SUBJECT: FIVE-YEAR REVIEW FOR INTEL SANTA CLARA 3

**Five-Year Review (Type I)**

**Intel Santa Clara 3  
2880 Northwestern Parkway  
Santa Clara, California**

Figure 2 TCE Concentrations in the A Water Bearing Zone - December 14, 1994 - Intel Santa Clara 3, Santa-Clara, California

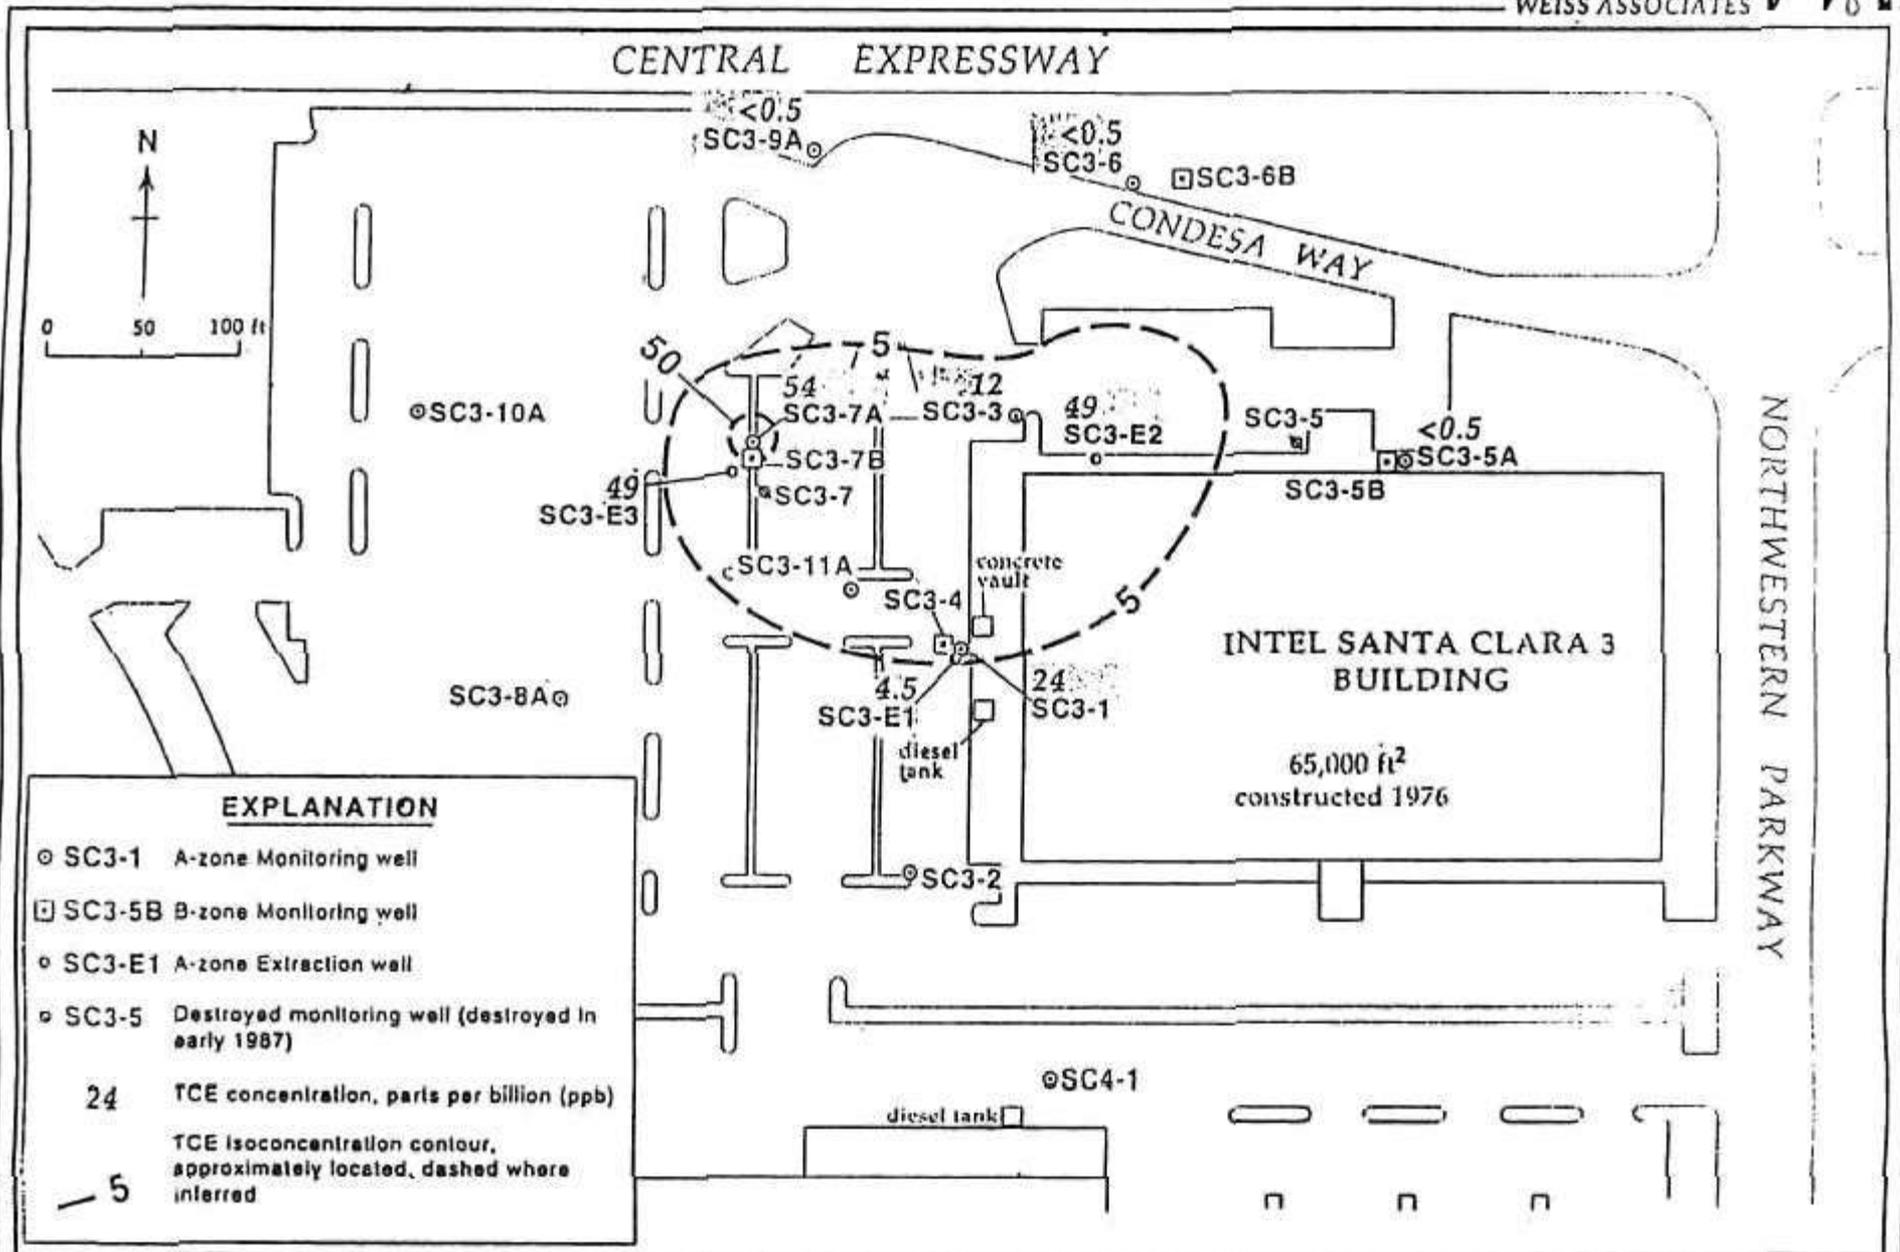
VOC concentrations in monitoring wells on-site appear to have reached asymptotic concentrations (see figure 2). A variety of cyclic pumping schemes were tried to see if the VOC removal efficiency could be improved. Cyclic pumping did not result in any significant improvement in removal efficiency.
